CITY OF HUBER HEIGHTS STATE OF OHIO

City Council Work Session

Case BDP 23-17 - BP-OTP, LLC - Rezoning/Basic Development Plan - 4949 Chambersburg Road

To: Huber Heights City Planning Commission

SITE PLAN

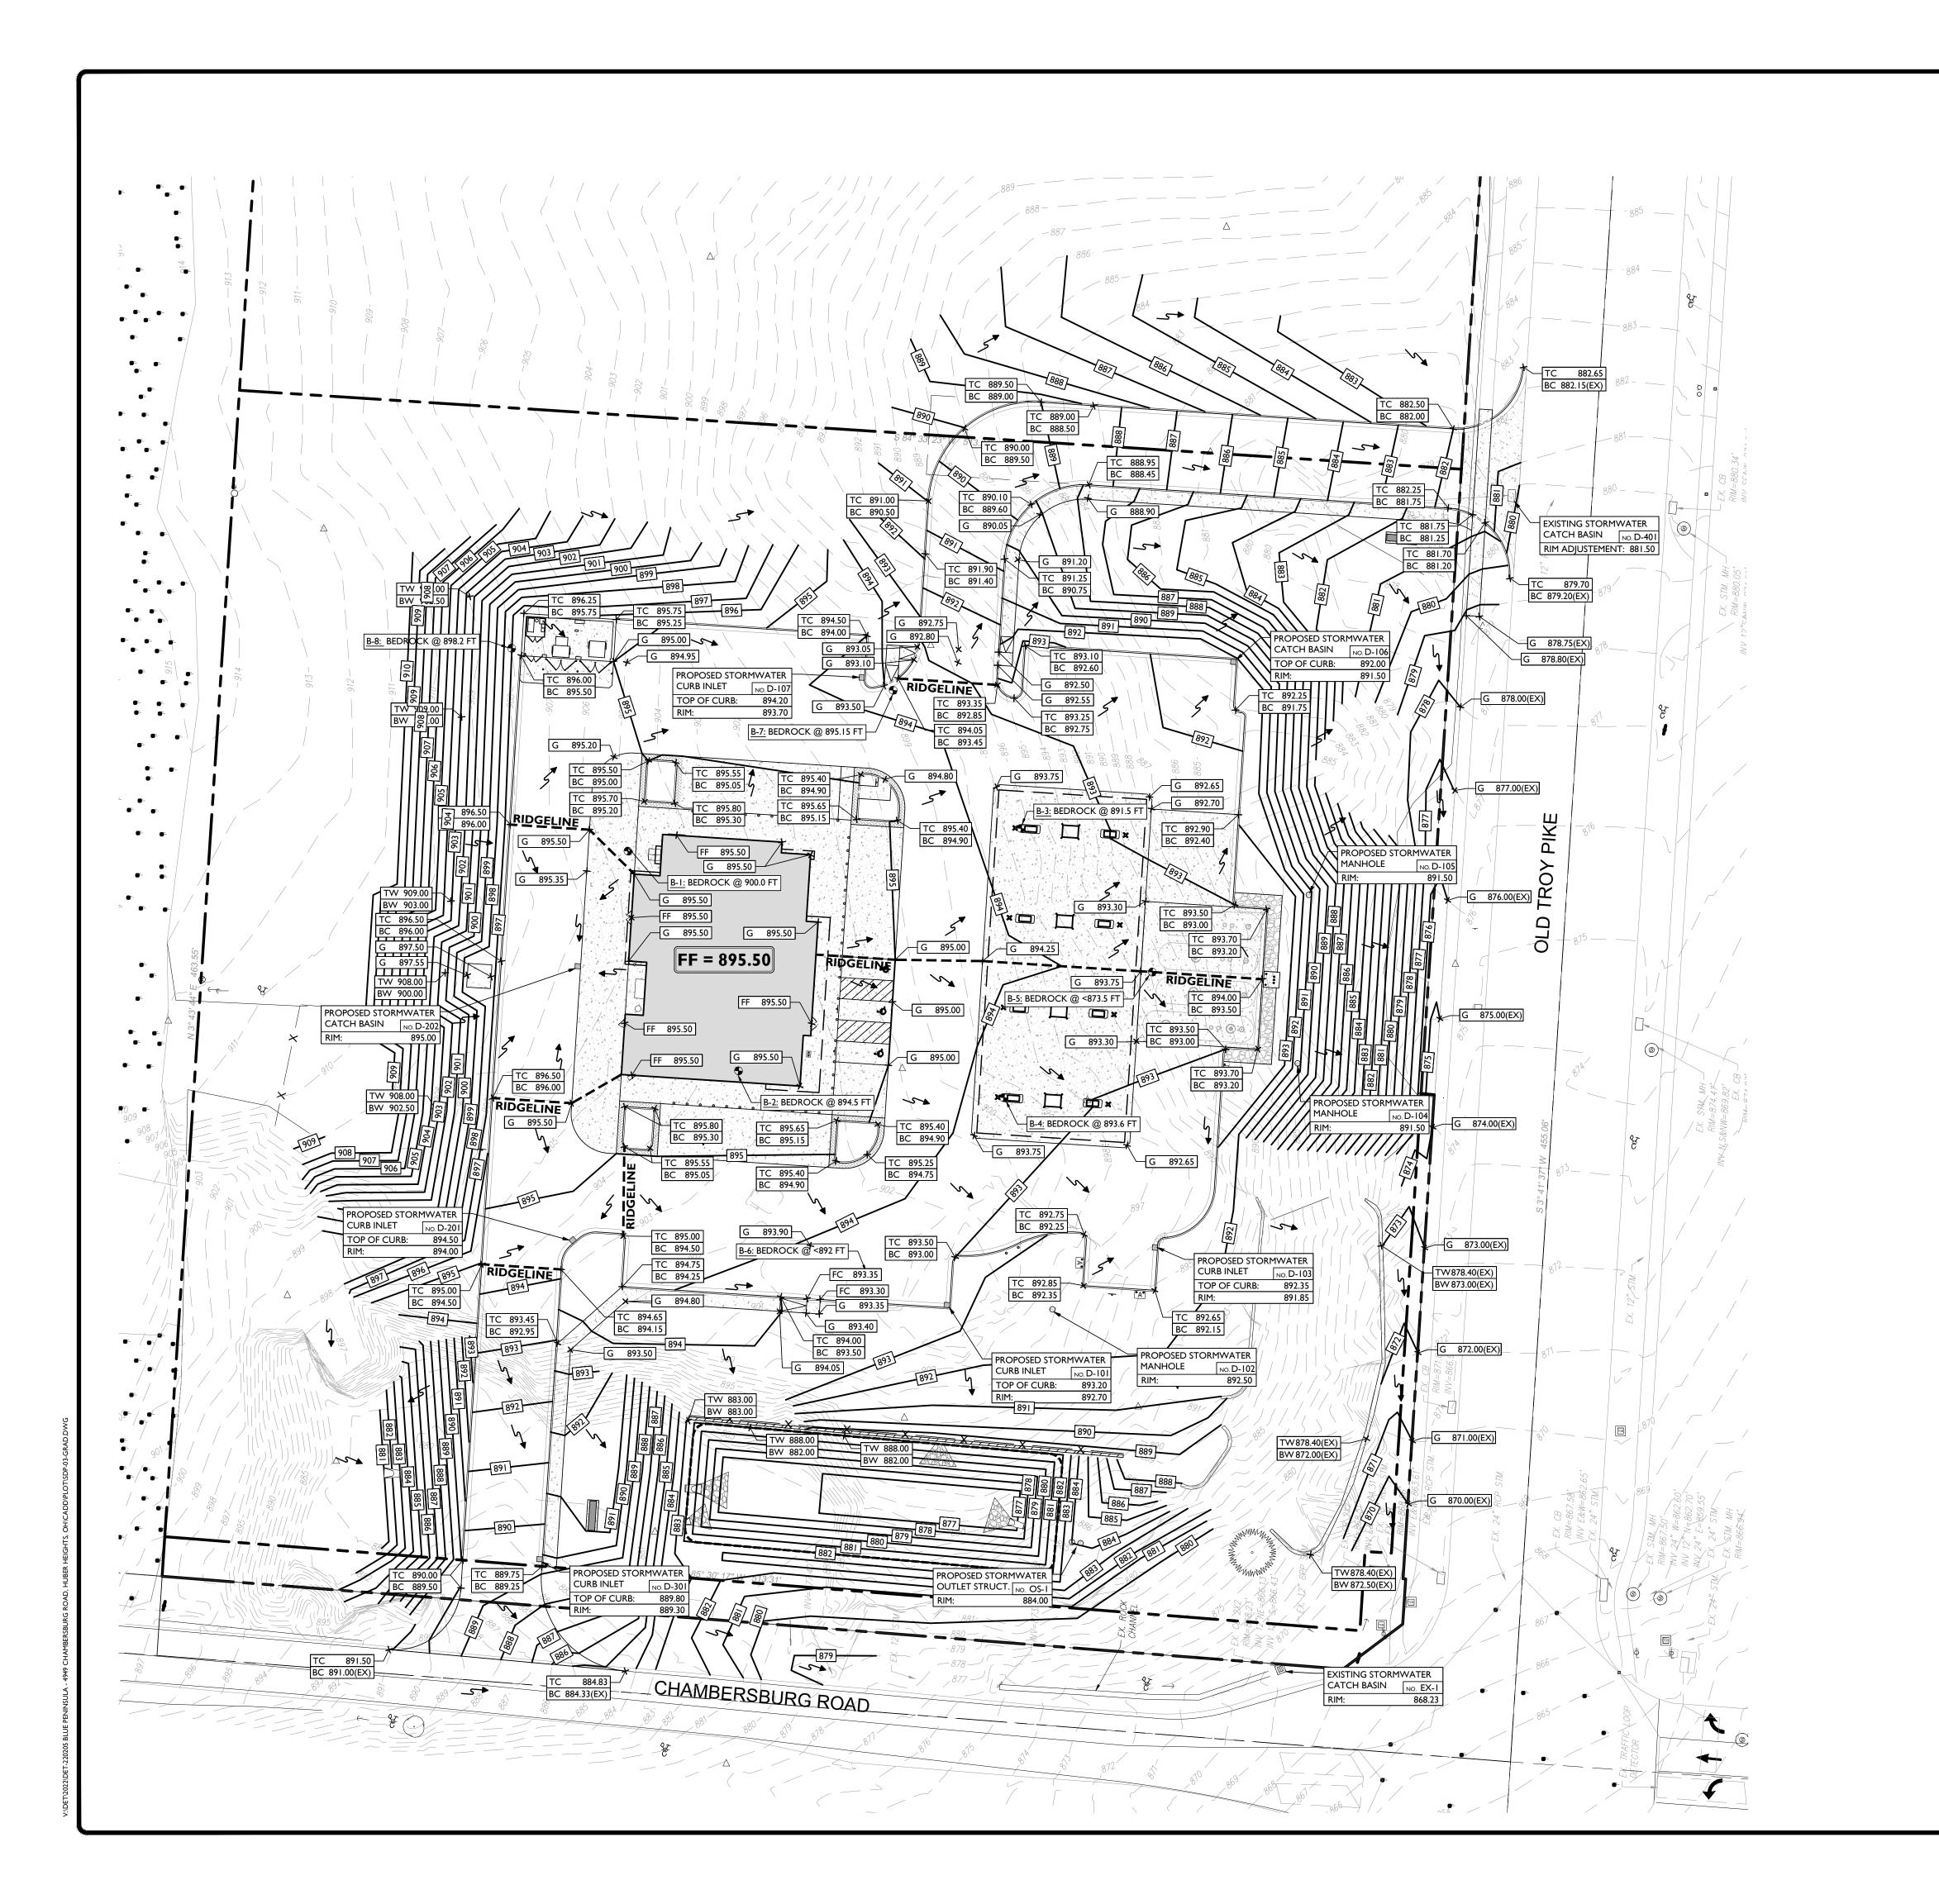
- The site plan meets all parking and building setback and yard requirements.
- Nineteen street trees are required. The preliminary landscaping plan shows 19 street trees. However, due to grading issues and Chambersburg Road's planned widening, most of them are not near the sidewalk. During the Detailed Development plan review, staff will work with the applicant to place the required trees appropriately.

The staff believes the site plan is generally well arranged, and internal circulation is efficient and compatible with the intended use. Pedestrian connections between the streets and the store are provided. The landscaping requirements will be reviewed with the Detailed Development application.

City Engineer: The engineer has reviewed the site plan and requested additional right of way along Old Troy Pike and Chambersburg Road. The applicant has indicated that they will revise their plans accordingly.

The applicant shall submit a revised Basic Development Plan indicating the corrected ROW dedication along Old Troy Pike and Chambersburg Road, as the City engineer requires.

GRADING PLAN

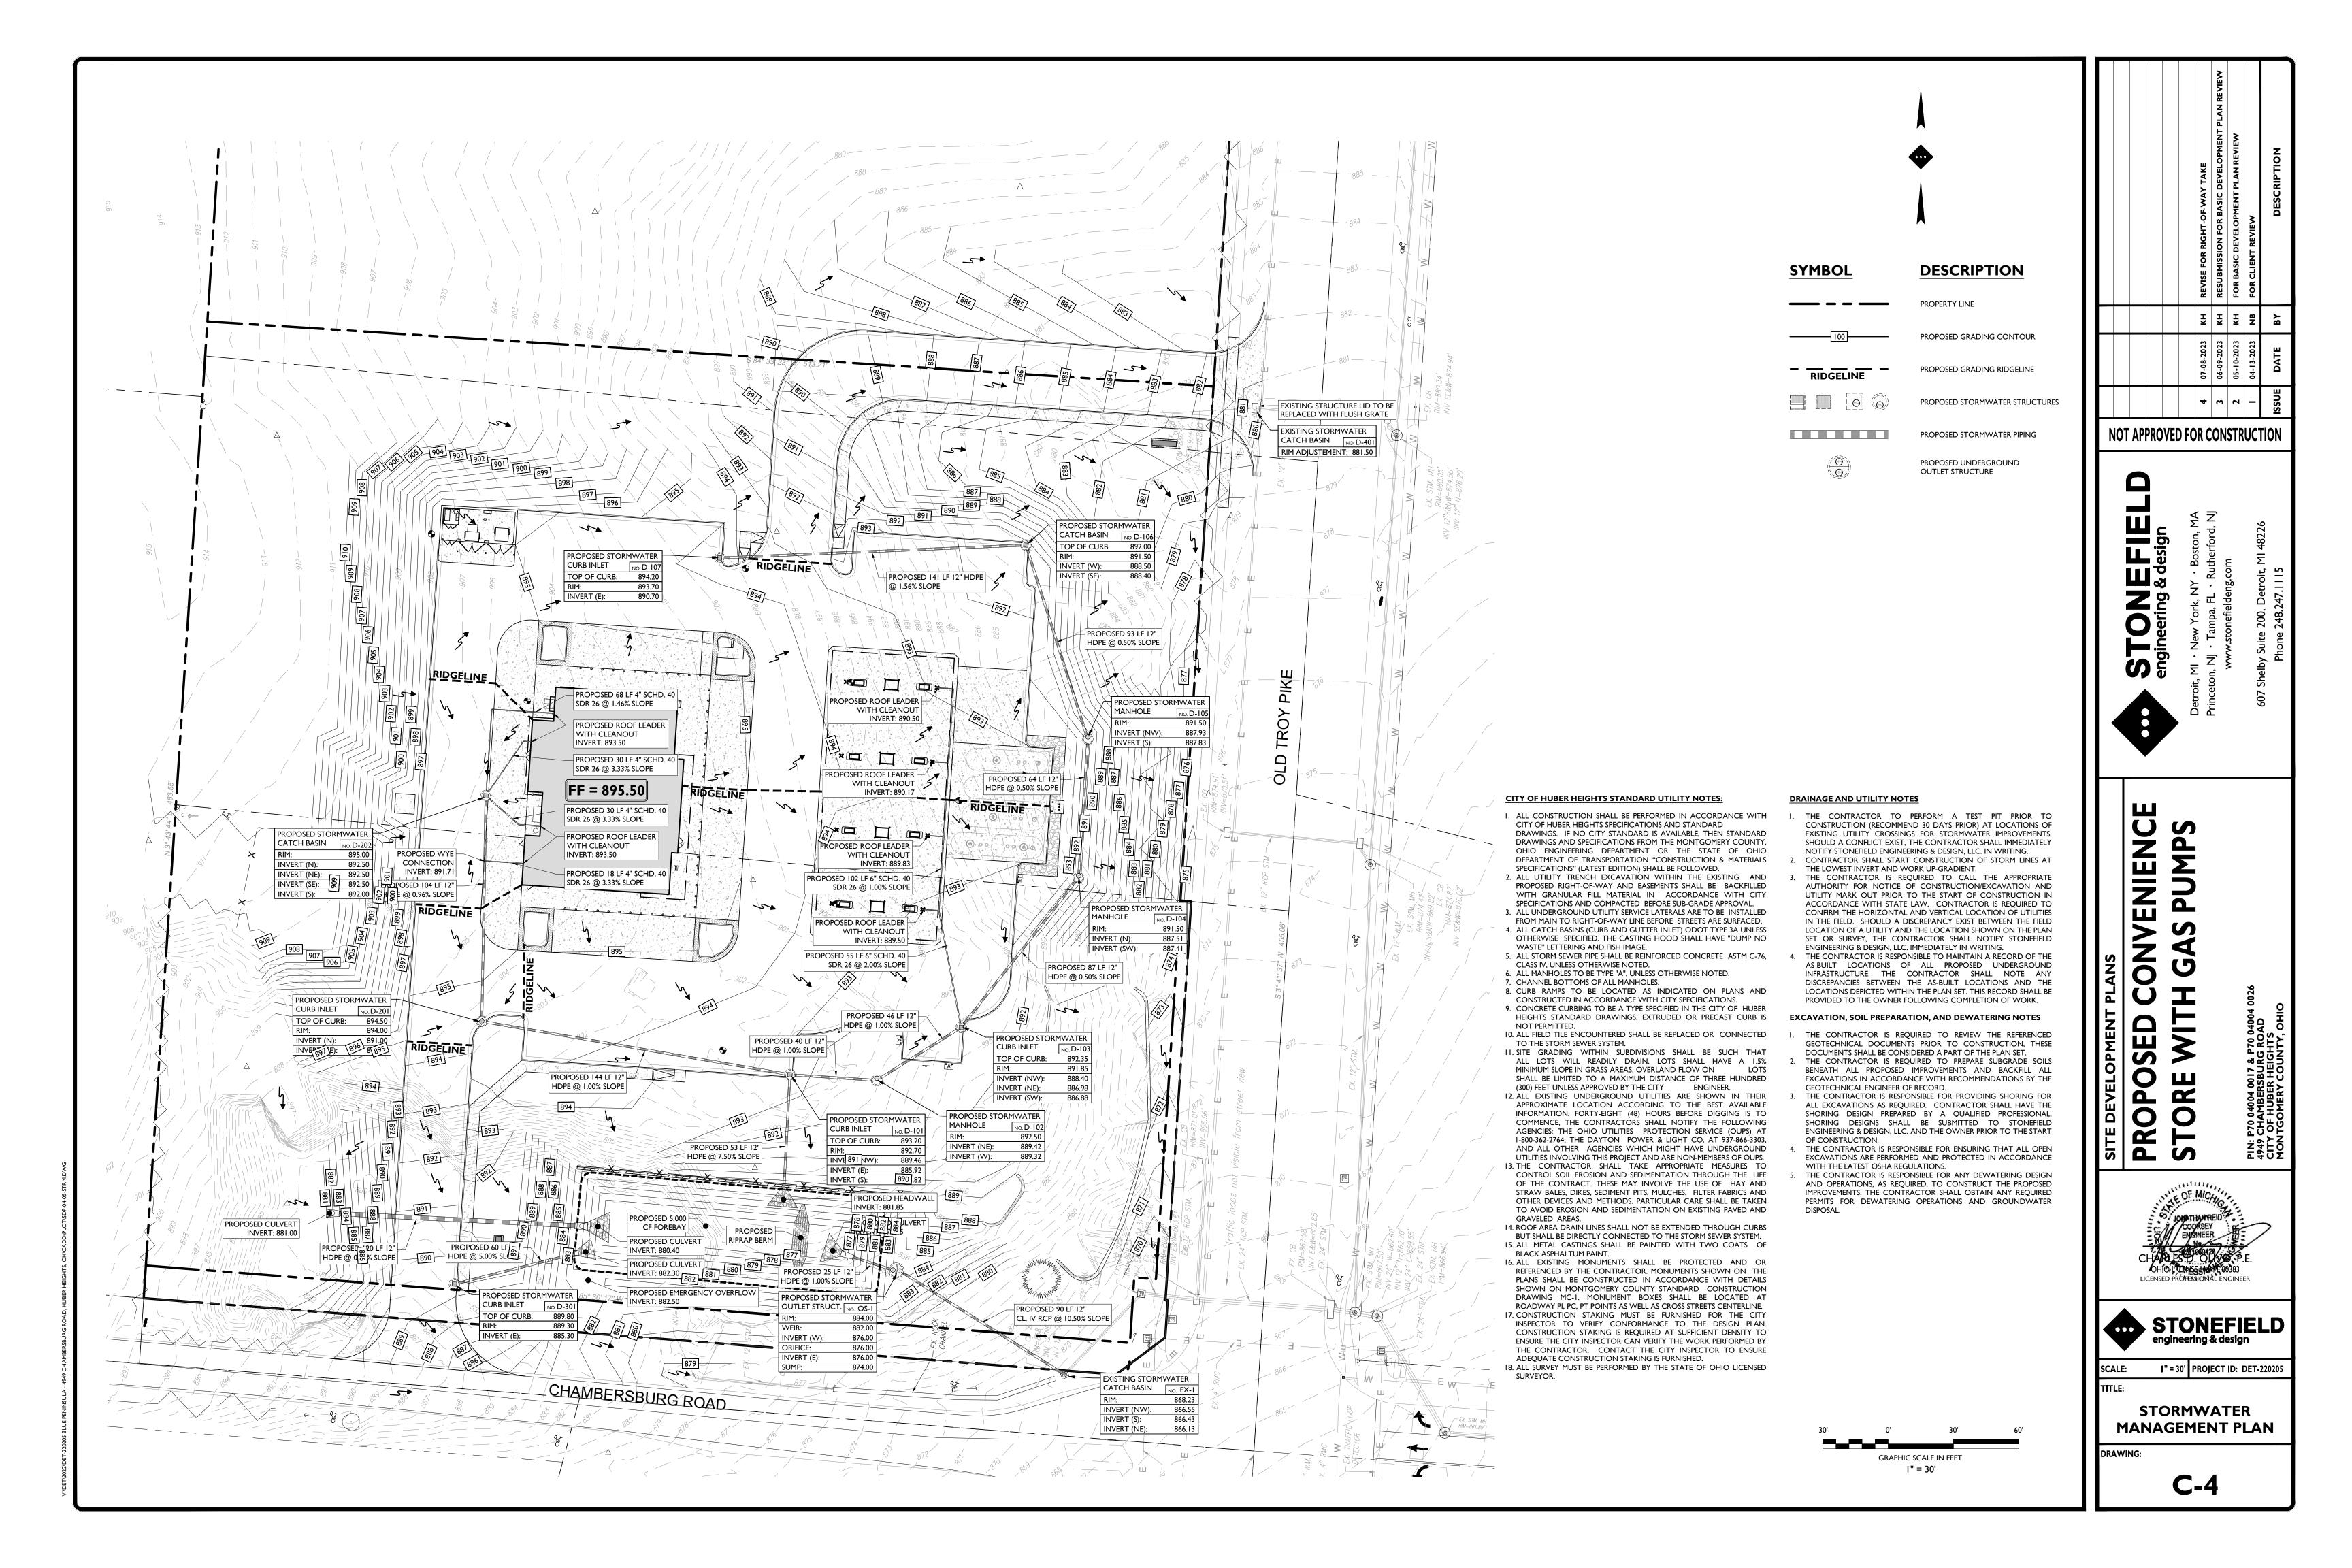
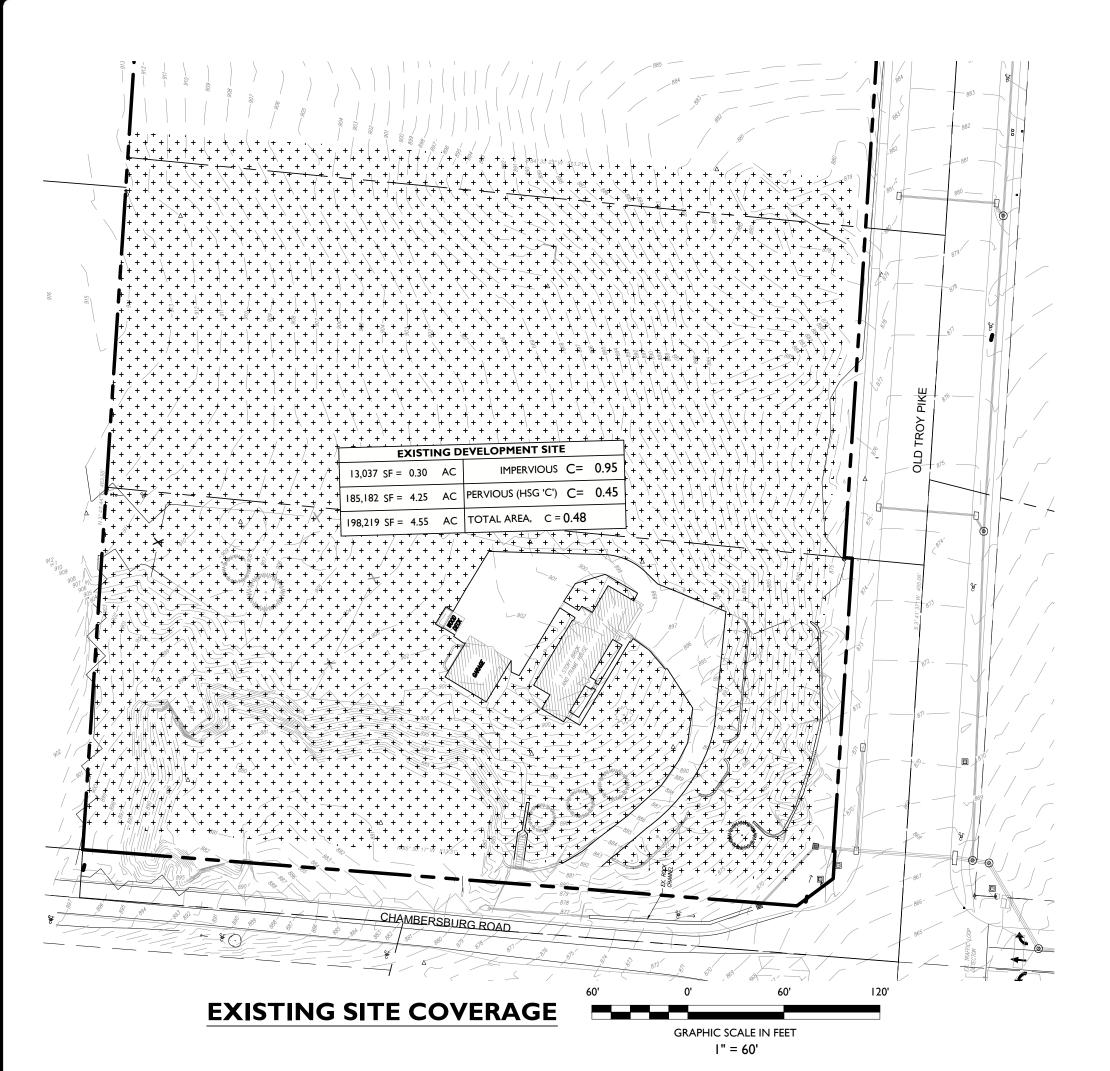
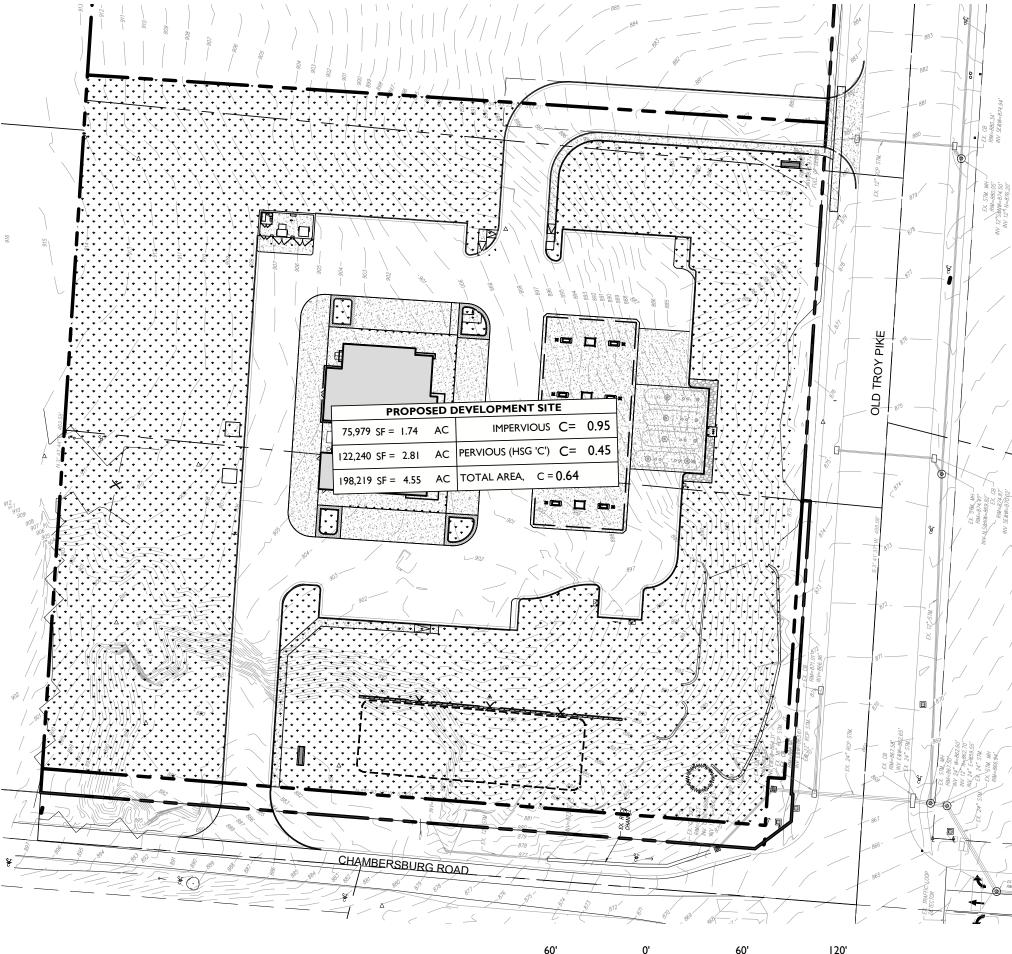
As discussed, the site has significant topographic features. The grading plan illustrates significant grading on the site's west, south and northeast edges. The grading should not impact the properties west or north of the site since there is an adequate buffer between the property lines and the extent of the grading activities. The applicant is grading to a 3:1 slope and providing vegetative ground cover, which will limit erosion.
